49 REEVES WAY WOKINGHAM RG41 2PS - Application Number: 260063**PROPOSED ERECTION OF A SINGLE STOREY REAR EXTENSION FOLLOWING DEMOLITION OF THE EXISTING CONSERVATORY, PLUS CHANGES TO FENESTRATION**

Objections to planning application on the grounds of size and mass of extension causing detrimental visual impact, intrusion of privacy and loss of aerial light to 51 Reeves Way

Sketch reference:
SK 20260129-1 Rev 1
29th Jan 2026

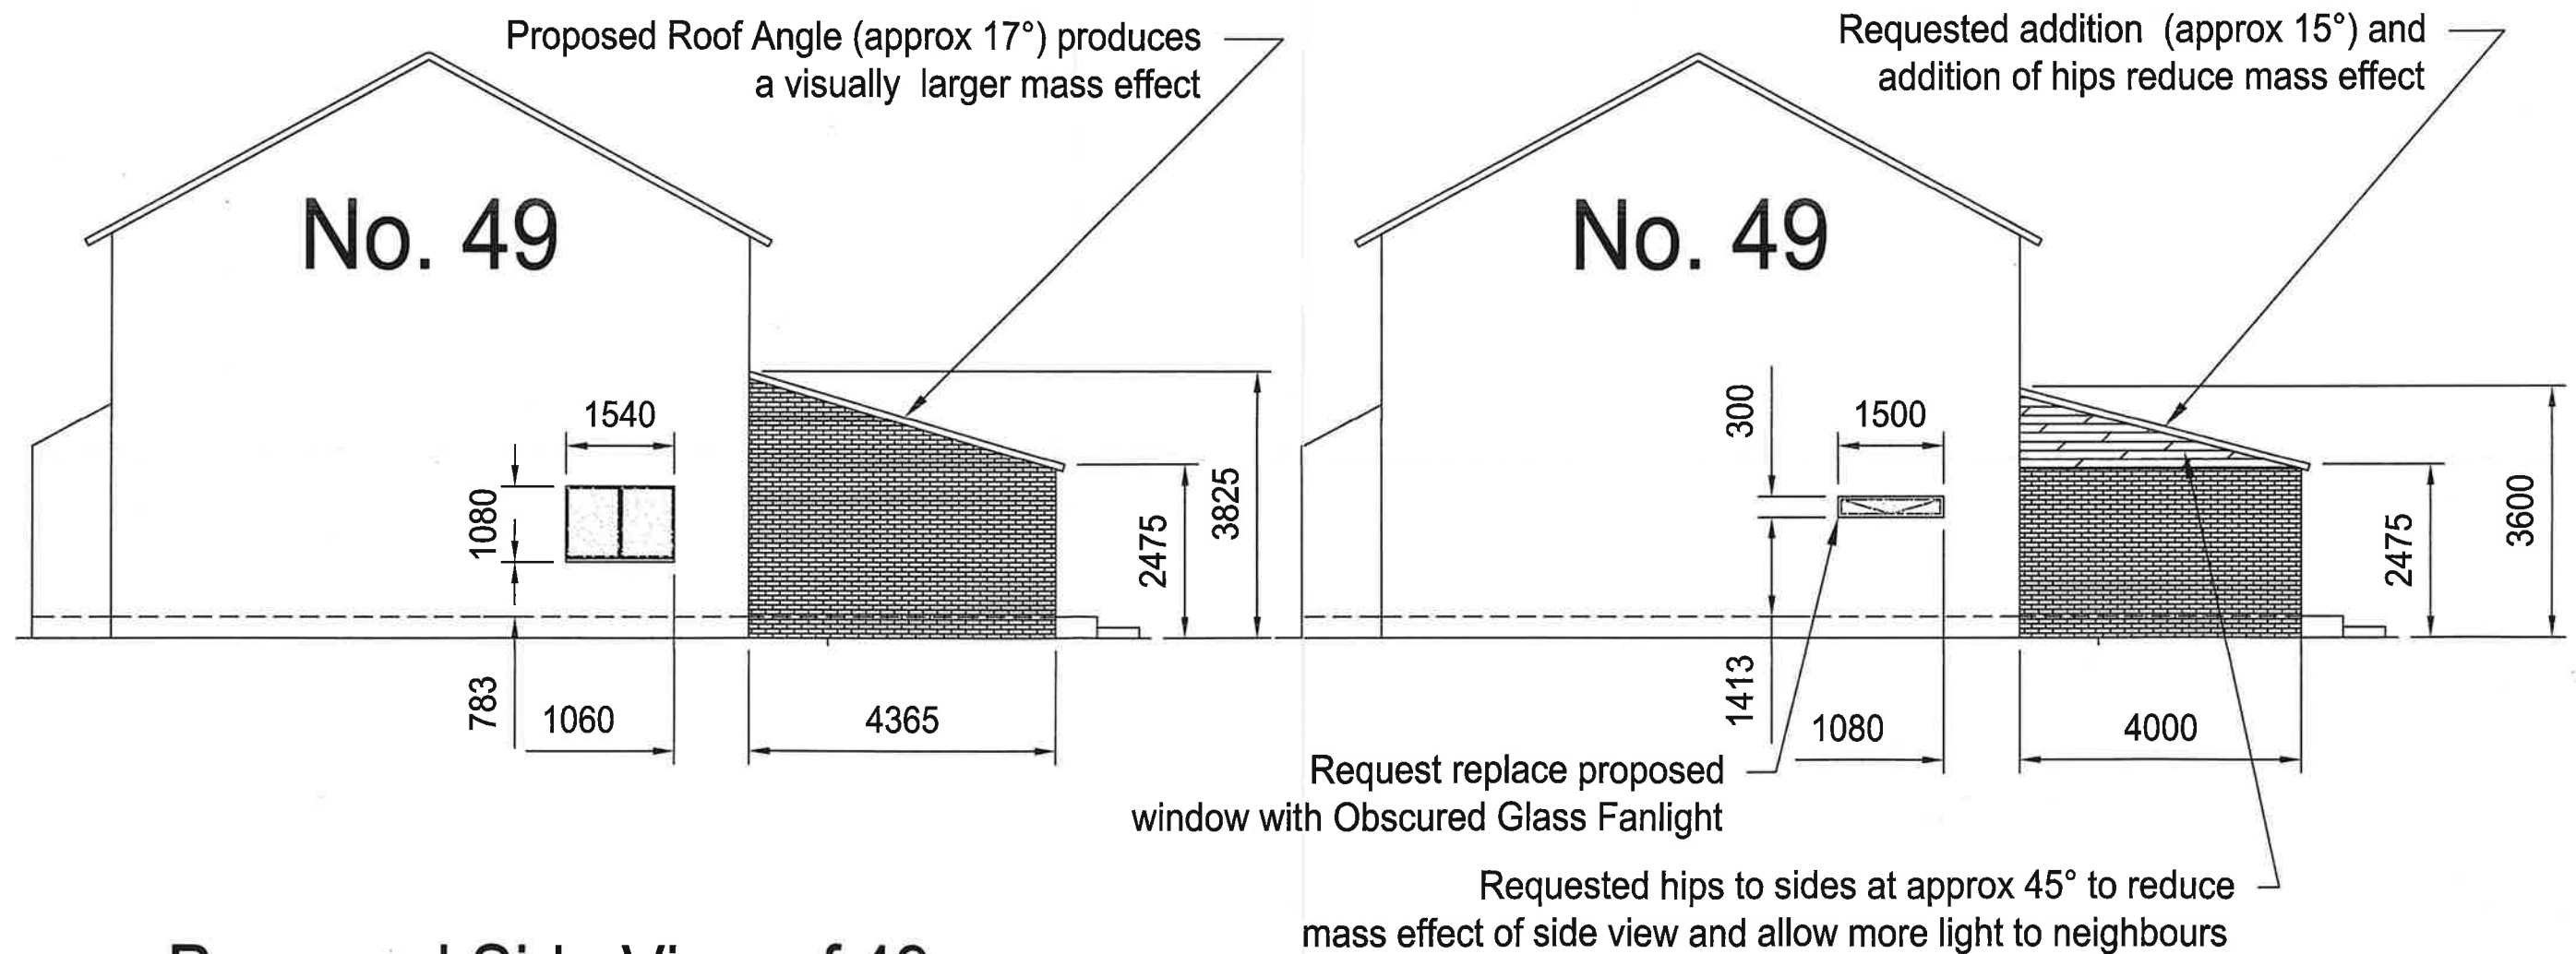
The new proposed window in the side wall of 49 Reeves Way, directly overlooking our property at 51 Reeves Way is very large – it is a double width, standard height window – and we therefore strongly object to the size and positioning of this window. Currently the plans show this new window without any label to say whether it has obscured glass.

We had previously spoken to the new owner of 49 Reeves Way and he had asked whether we would have any objection to a fanlight design window in this wall and we had indicated that we would not. So we are surprised by the drawing of a double width and full height window on the planning application plans. We would want this window amended to a fanlight design set as high as possible (and without it compromising the roof structure of the existing lean-to storage area between 49 and 51 Reeves Way). We would naturally want this higher fanlight window to have obscured glass to prevent overlooking onto our property.

Side Views

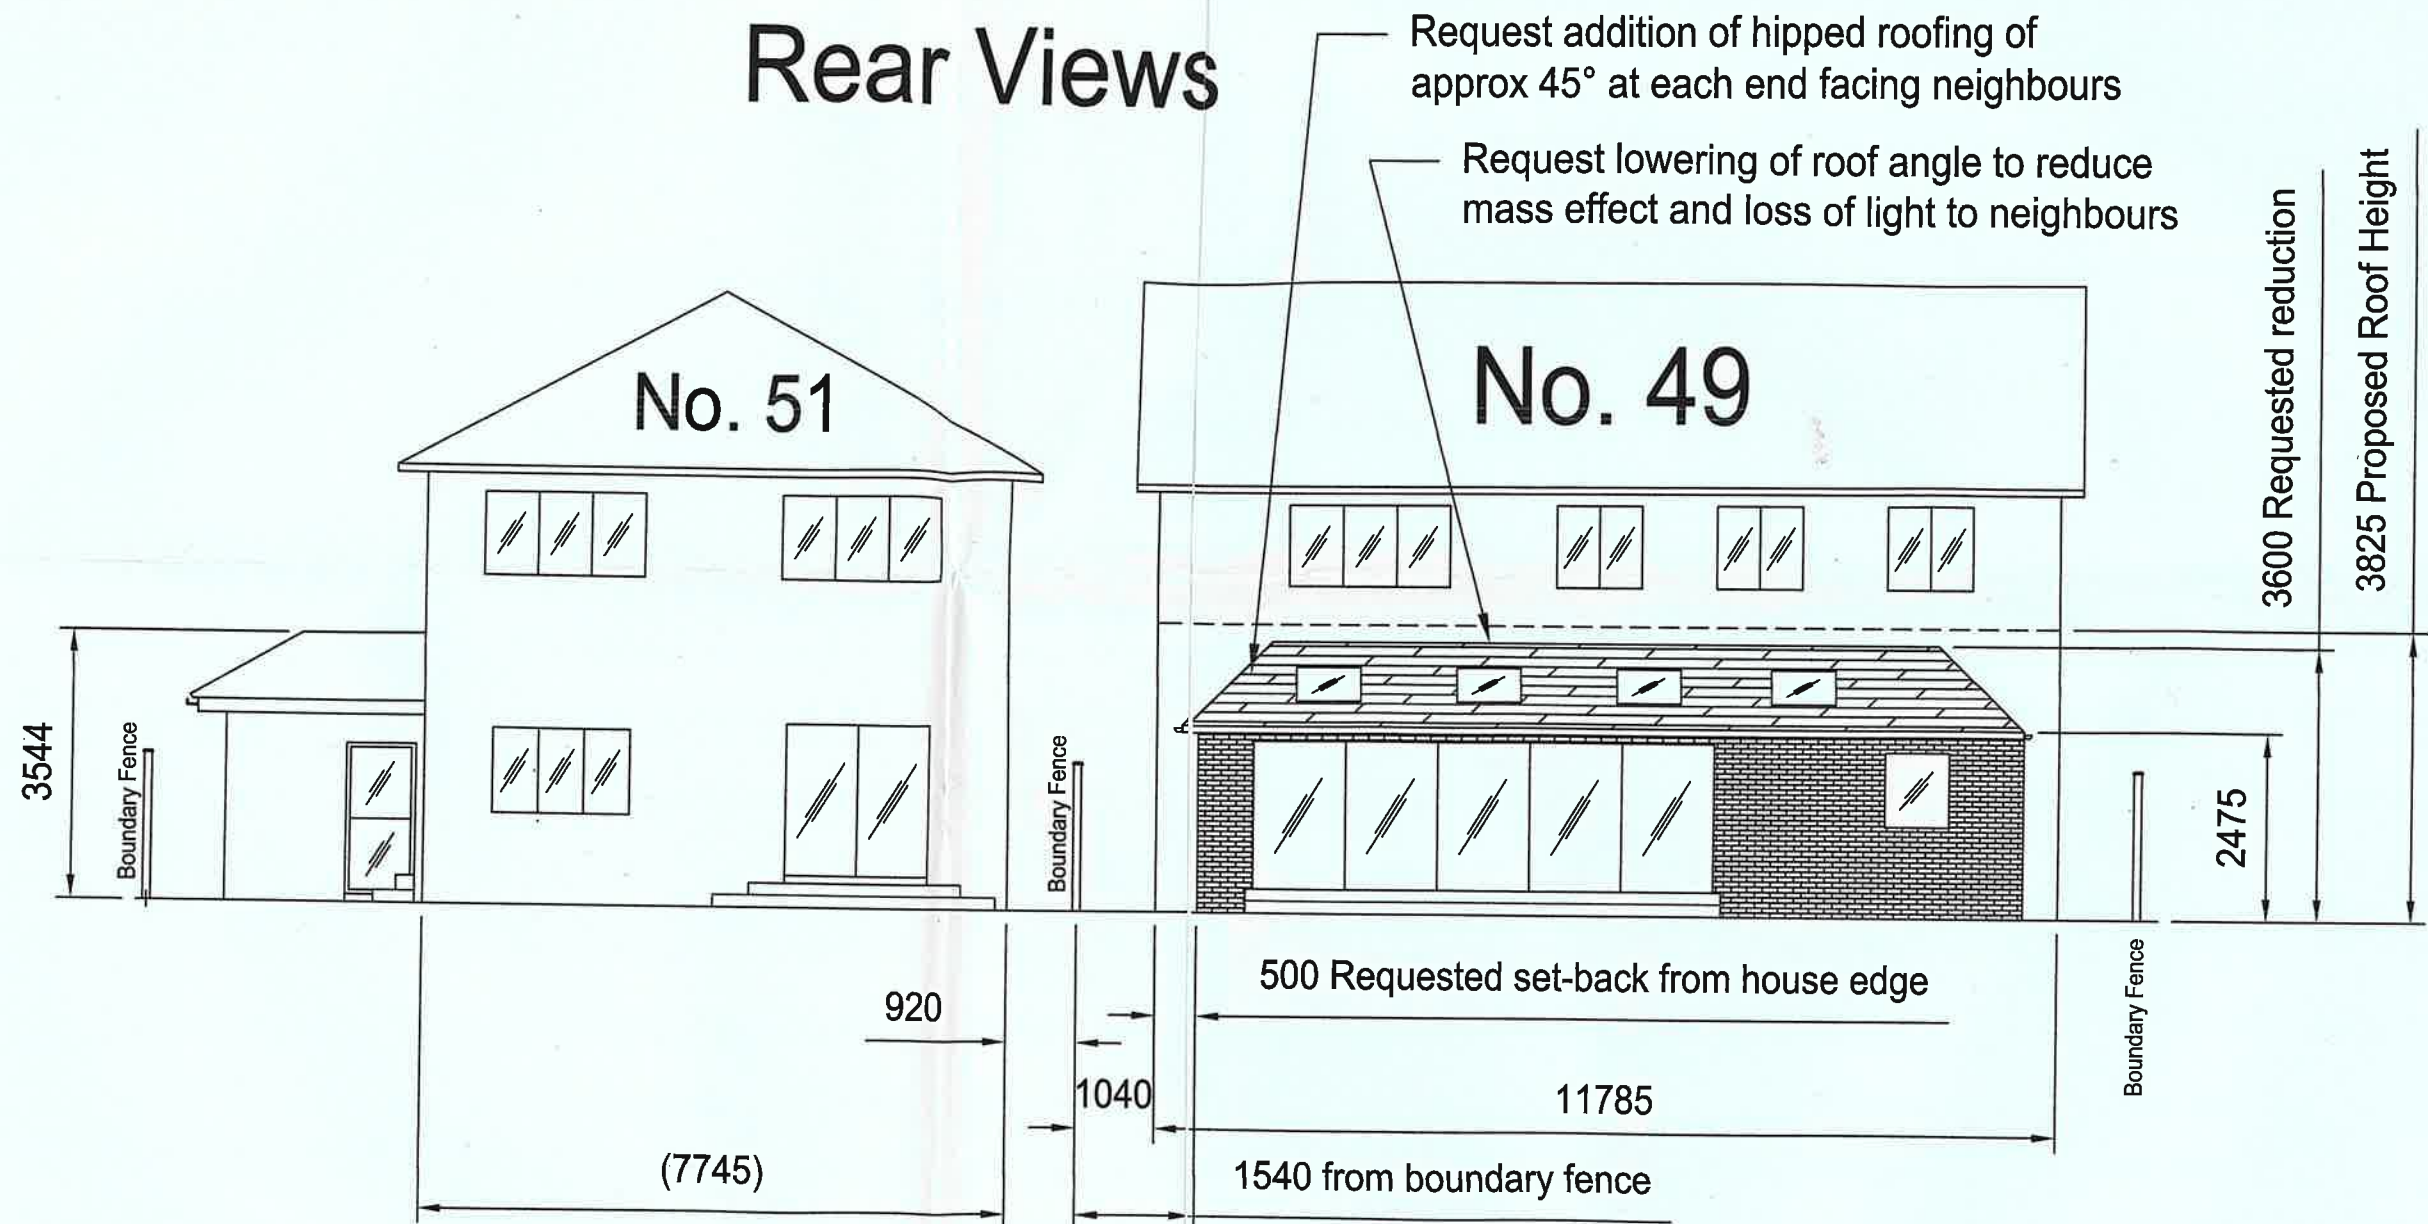
The proposed extension is 4365mm in depth from the existing rear wall of 49 Reeves Way and this is in contravention of the Borough's Design Guide which states "Rear extensions should not project more than four metres from the main wall where they are close to a side boundary". The distance from the wall of the proposed new extension to the side boundary of the property where the fence-line between 49 Reeves Way and 51 Reeves Way is only 1004mm.

I would therefore prefer the extension to be the maximum of 4 metres and that it should have a hipped roof design, where there are 3 pitches of roofline as shown on the diagram attached to the hardcopy of this document. (Document will be delivered by hand to the Council's offices, prior to the deadline for comments.)

I am requesting that the design of the roof is sloped in from both sides, as well as the rear facing slope (ie 3 sides to the roof pitch), this will reduce the mass effect of the brick wall and help to mitigate some of my concerns. A hipped roof will result in the new side brick wall being lower in height along its length with a small side pitched roof sloping away from our property. This will be much less bulky and less overbearing in appearance. This hipped style roof will also match the shapes of the existing side and rear ground floor portions of many nearby buildings namely:

- i) A shallower pitch of roof would not block out as much light from the side of our property.

- ii) A request that the extension be set back from the house edge at approximately 500mm as is often done with a rear extension close to a boundary (within approx. 1000mm). This would again reduce the overbearing impact of the extension.
